PRODUCT/PROCESS CHANGE NOTICE (PCN)

PCN #: TB1311-01 DATE April 9, 2014 Product Affected: VFQFPN-28, VFQFPN-40, VFQFPN-48 shipped in Tape & Reel (Refer to Attachment II for affected part#) Date Effective: July 9, 2014	MEANS OF DISTINGUISHING CHANGED DEVICES: <input type="checkbox"/> Product Mark <input type="checkbox"/> Back Mark <input type="checkbox"/> Date Code Shipment starting from July 9, 2014. <input checked="" type="checkbox"/> Other
--	--

ATTACHMENT I - PCN #: TB1311-01

Detail of Change: This notification is to advise our customers that IDT has qualified a new revision of carrier tape for package VFQFPN-28, VFQFPN-40 and VFQFPN-48.

Figure1: Illustration of Existing Carrier Tape Pocket and New Carrier Tape Pocket

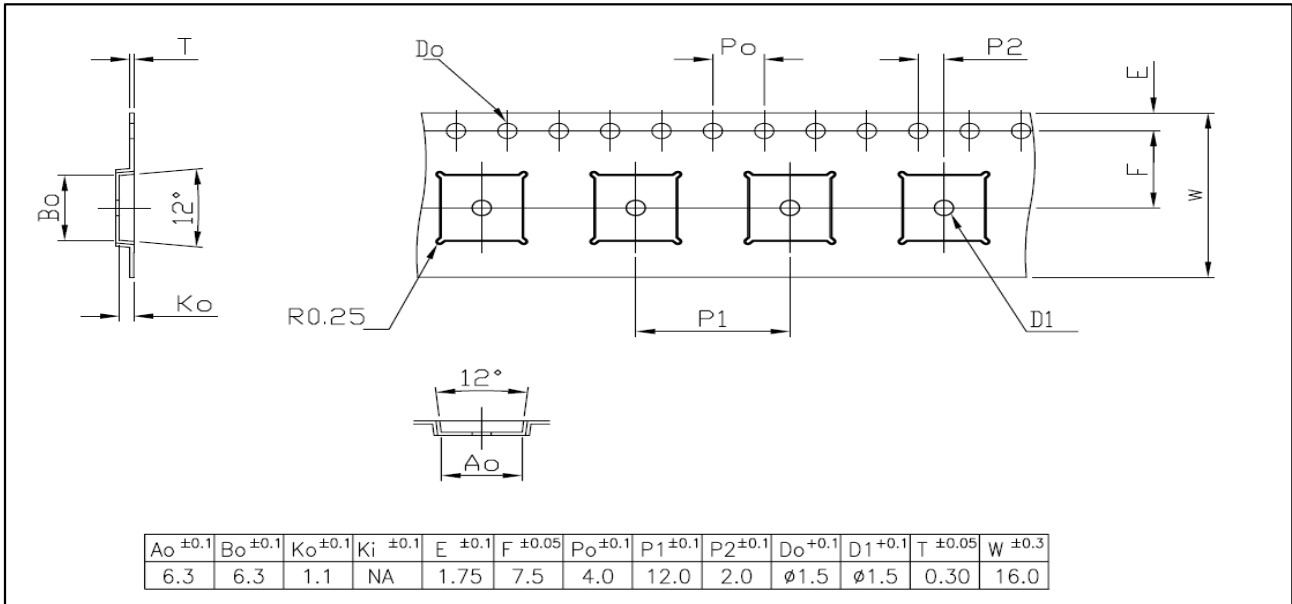
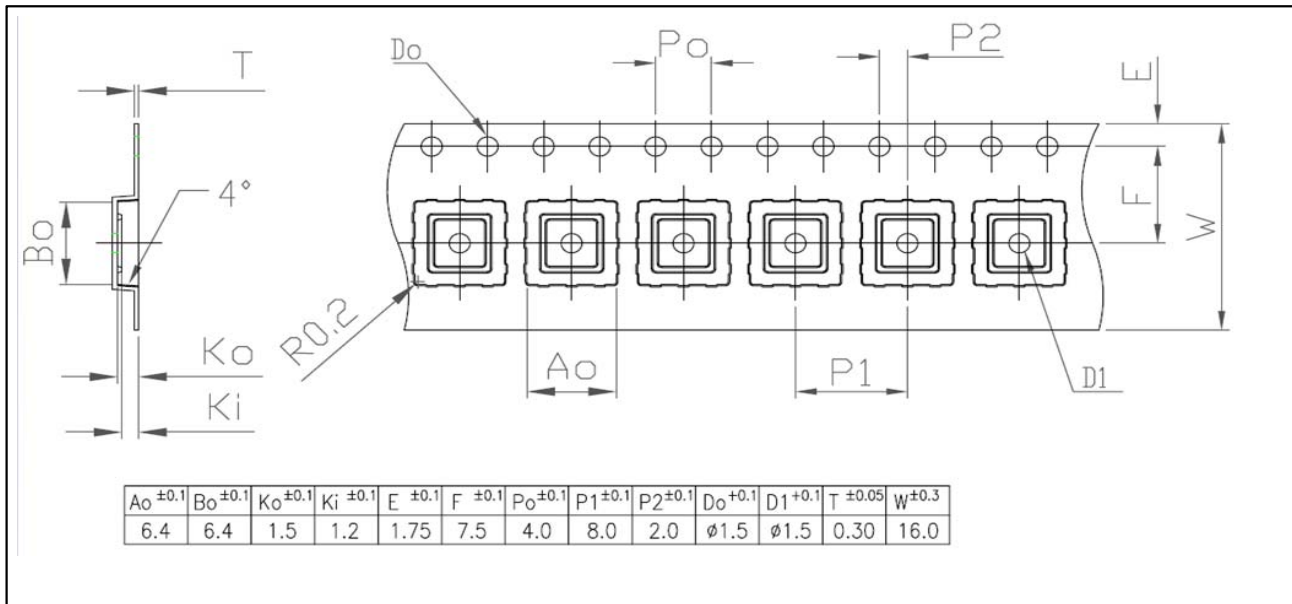
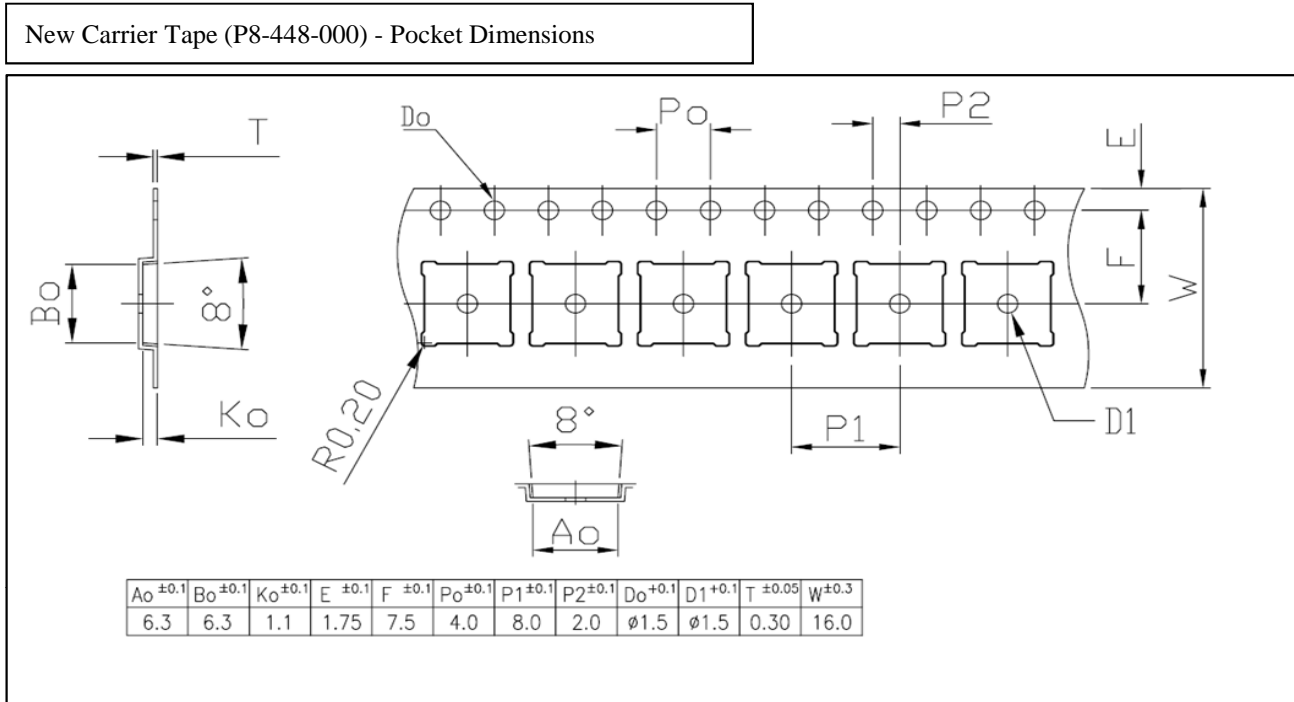
The new carrier tape has changes in pocket design and dimensions however quantity per reel remains unchanged.

Refer to to Table 2, Figure 1 and 2 for the comparison of the existing and new carrier tape in terms of carrier tape pocket dimensions and pocket designs respectively.
